SFEIS DEFICIENCIES - RECAP

**RE: Parcel B Office Building; Comments on DSEIS
2 Manhattanville Road
Block 631 Lot 17**

THE CENTRE AT PURCHASE
PURCHASE, NEW YORK

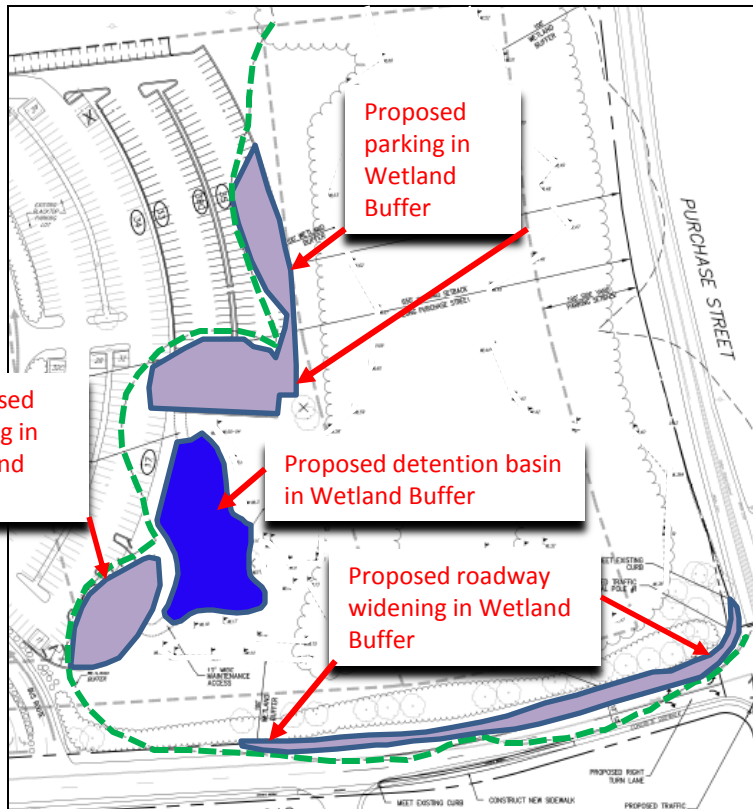
1. As quantified in the text, total buffer disturbance equals 1.52 acres. The applicant states that of this 1.52 acres, the stormwater basin accounts for 0.74 acres of disturbance. The Applicant states that the planted basin will provide habitat, and therefore should be counted as part of the compensatory mitigation. While we agree that planted stormwater basins serve important functions typically associated with wetlands, provision of habitat is not one of them as the basins collect and treat polluted runoff from developed areas. For this reason, stormwater basins are not counted towards the mitigation area, particularly when they are located within the regulated area. As no other form of compensatory mitigation is offered, the proposed impacts to the wetland buffer will have a potential adverse impact on the wetland. Some form of compensatory mitigation should be proposed by the Applicant and detailed in the FEIS.

FIGURE II.Ca-1

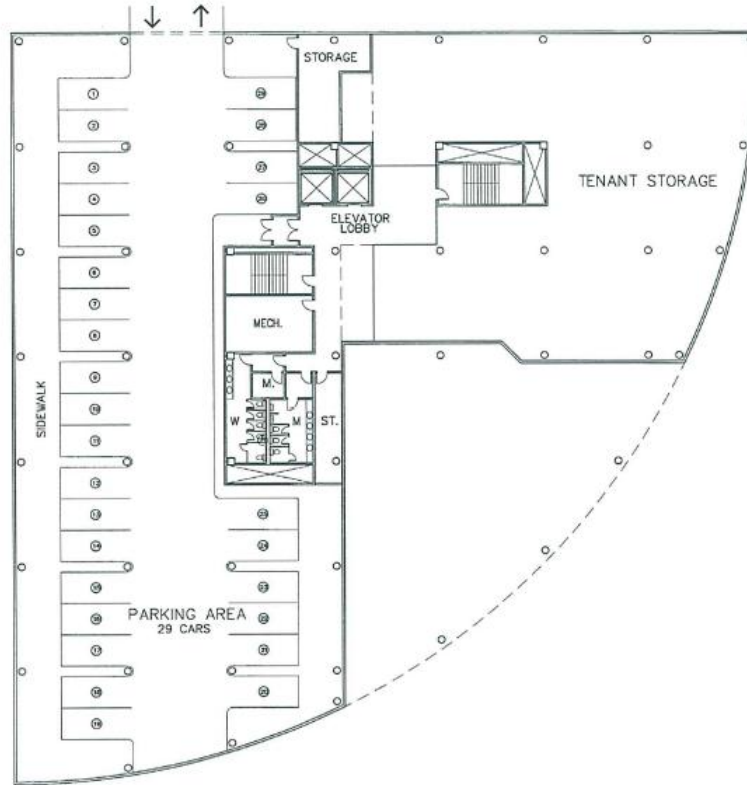
1. UNCLEAR HOW PARKING ACCESS AT LOWER LEVEL CAN BE PROVIDED
2. CONTRADICTORY FLOOR PLANS
3. EMERGENCY (FIRE) ACCESS TO THE BUILDING IS UNCLEAR

TITLE:
LOWER LEVEL PLAN

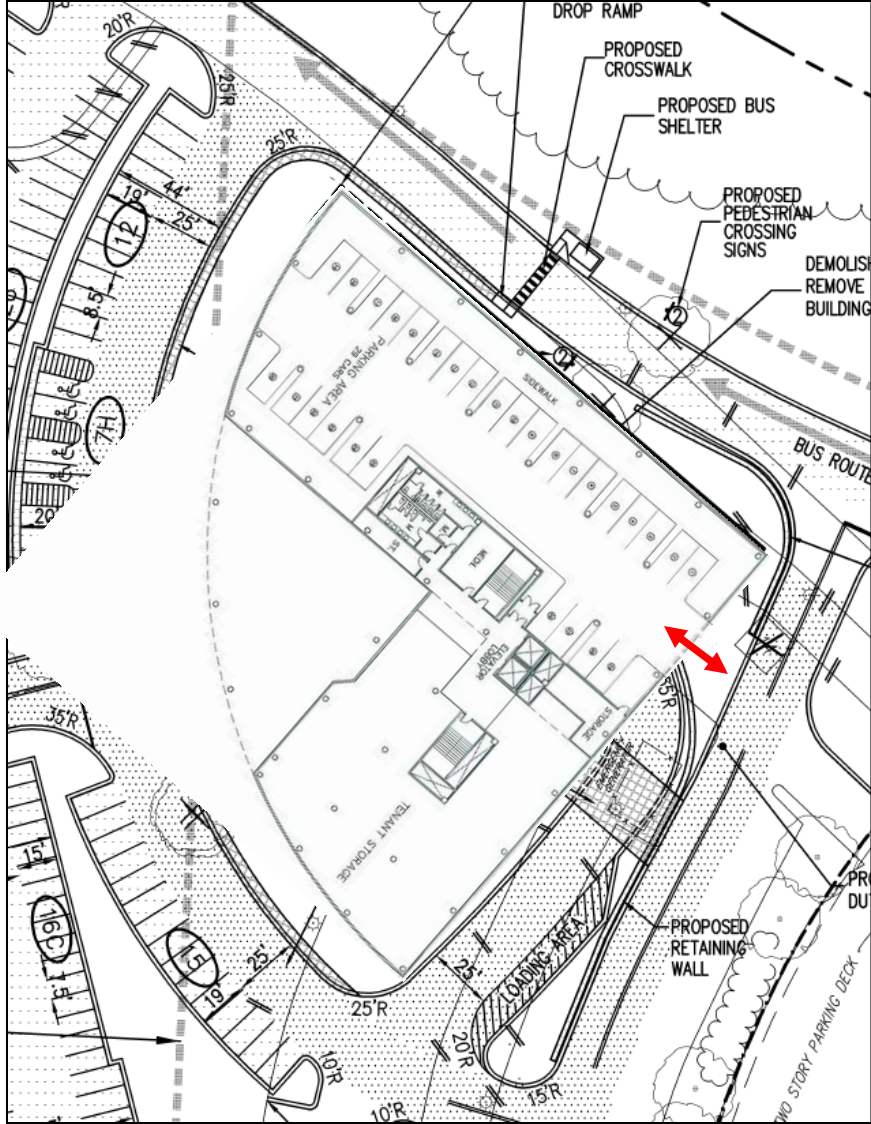
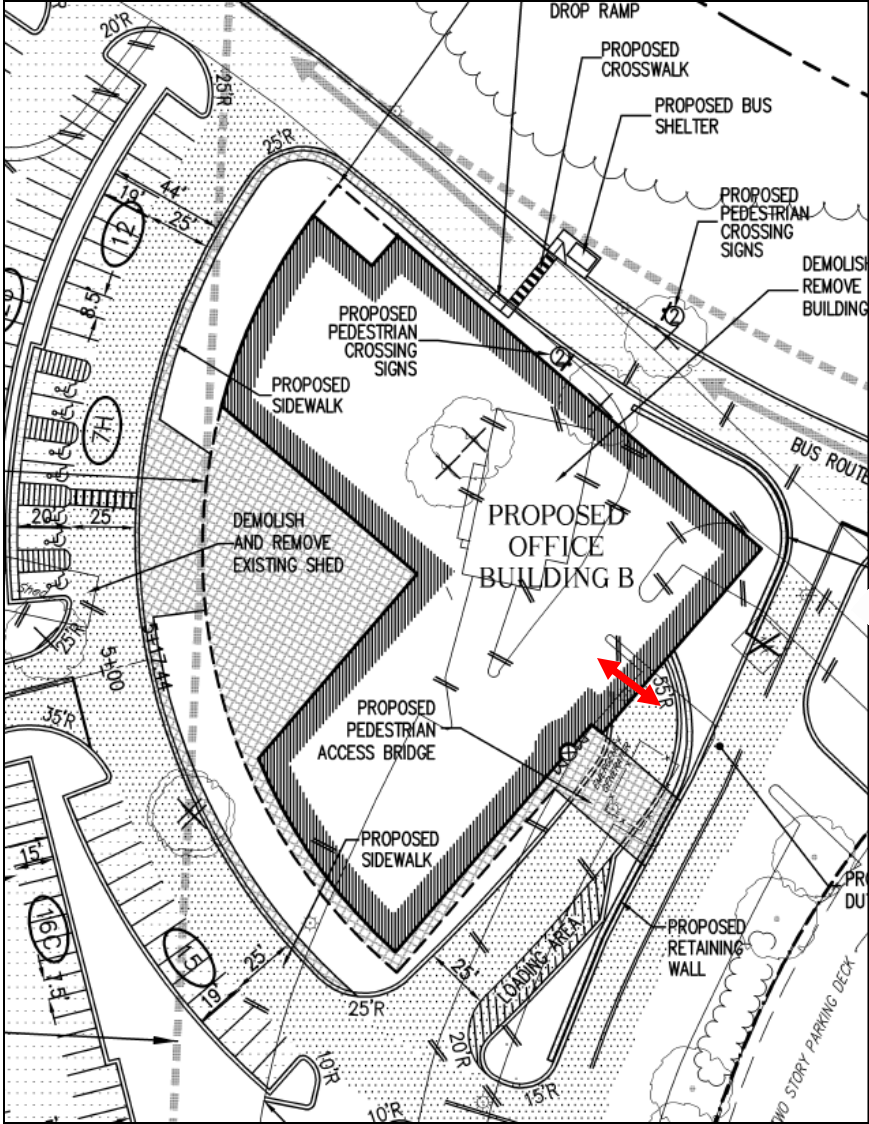
LOWER LEVEL PARKING ISSUES

BUILDING REPRESENTATION

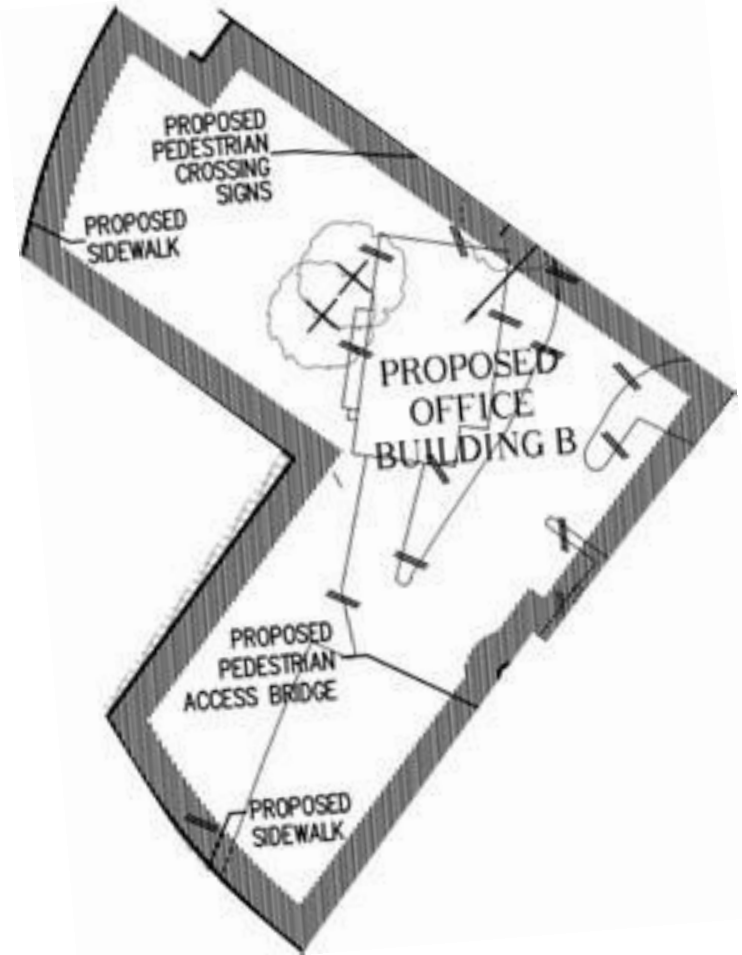
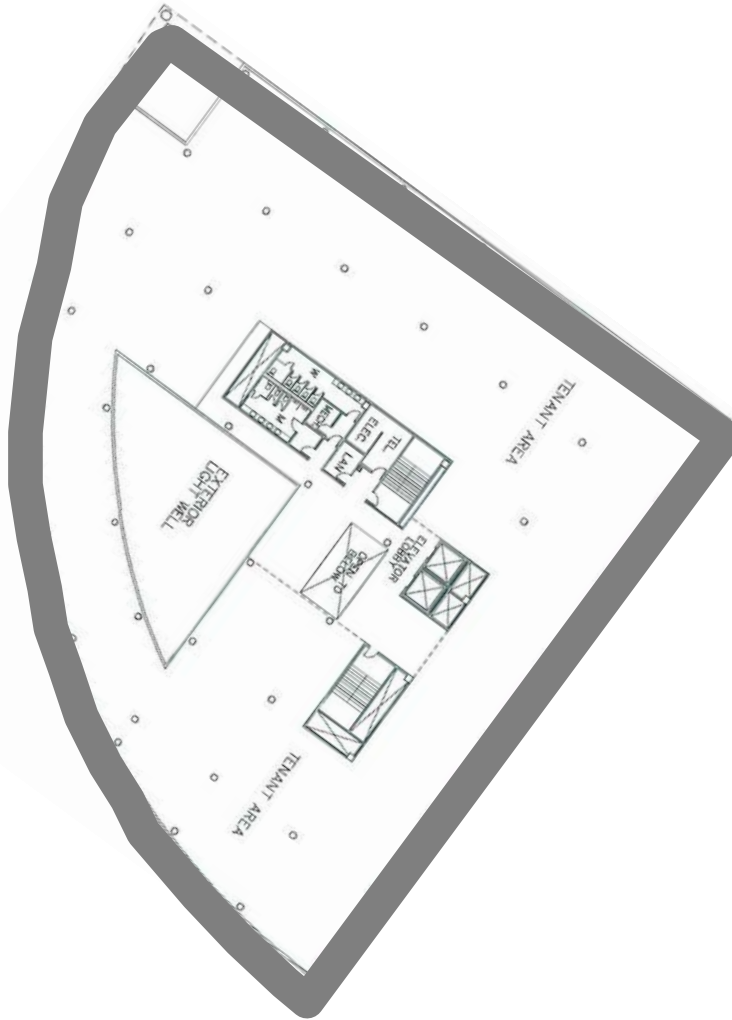
INCORRECT FLOOR AREA

<u>FLOOR (BELOW GRADE)</u>	<u>STAIRS</u>	<u>ELEVATORS</u>	<u>MECH. SHAFTS</u>	<u>MECH. RM.</u>	<u>STORAGE</u>	<u>TOILETS</u>
LOWER LEVEL	622	233	638	470	8,906	659

<u>FLOOR (ABOVE GRADE)</u>	<u>STAIRS</u>	<u>ELEVATORS</u>	<u>MECH. SHAFTS</u>	<u>MECH. RM.</u>	<u>MECH. CONV.</u>	<u>TEL. RM.</u>	<u>ELEC. RM.</u>	<u>COM. RM.</u>	<u>TOILETS</u>	<u>OPEN TO BELOW</u>
FIRST FLOOR	622	233	638	67	404	132	124	98	659	255
SECOND FLOOR	622	233	638	67	402	132	124	98	659	1278
THIRD FLOOR	622	233	638	67	501	132	124	98	659	3290
TOTAL (SQ. FT.)	1866	699	1914	201	1307	396	372	294	1977	4823

<u>FLOOR (ABOVE GRADE)</u>	<u>GROSS SQUARE FOOTAGE</u>		<u>NET SQUARE FOOTAGE</u>			<u>USABLE SQUARE FOOTAGE</u>			<u>PARKING SQUARE FOOTAGE</u>			
FIRST FLOOR	24,891	(-255)	24,636	24,636	(-1696)	22,940	24,636	(-1493)	23,143	24,636	(-2977)	21,659
SECOND FLOOR	26,693	(-1278)	25,415	25,415	(-1694)	23,721	25,415	(-1493)	23,922	25,415	(-2975)	22,440
THIRD FLOOR	34,806	(-3290)	31,516	31,516	(-1793)	29,723	31,516	(-1493)	30,023	31,516	(-3074)	28,442
TOTAL (SQ. FT.)			81,567			76,384			77,088			72,541

FIGURE II.Ca-1

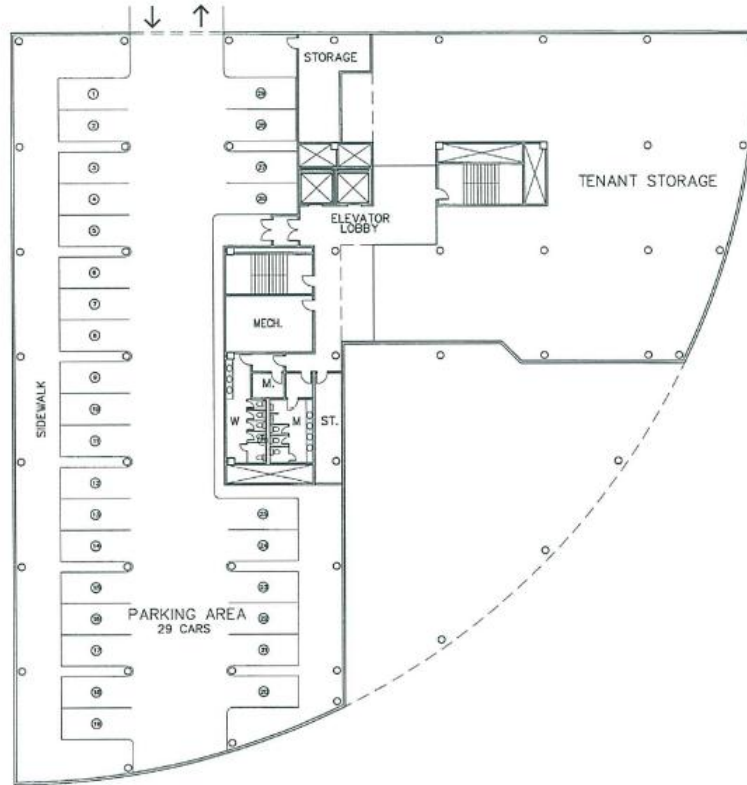
INCORRECT FLOOR AREA

DSEIS					
Floor	Total Floor Area	Gross Square Footage	Net Square Footage	Usable Square Footage	Parking Square Footage
1st	24,891	24,636	22,940	23,143	21,659
2nd	26,693	25,415	23,721	23,922	22,440
3rd	34,806	31,516	29,723	30,023	28,442
Total	86,390	81,567	76,384	77,088	72,541

Berger					
Floor	Total Floor Area	Gross Square Footage	Net Square Footage	Usable Square Footage	Parking Square Footage
1st	26,353	26,110	24,481	24,221	23,117
2nd	28,415	26,913	25,284	25,024	23,920
3rd	38,730	34,955	33,326	33,066	31,962
Total	93,498	87,978	83,091	82,311	78,999

Lower Level			8,906		
-------------	--	--	-------	--	--

Grand Total			91,997		
--------------------	--	--	---------------	--	--
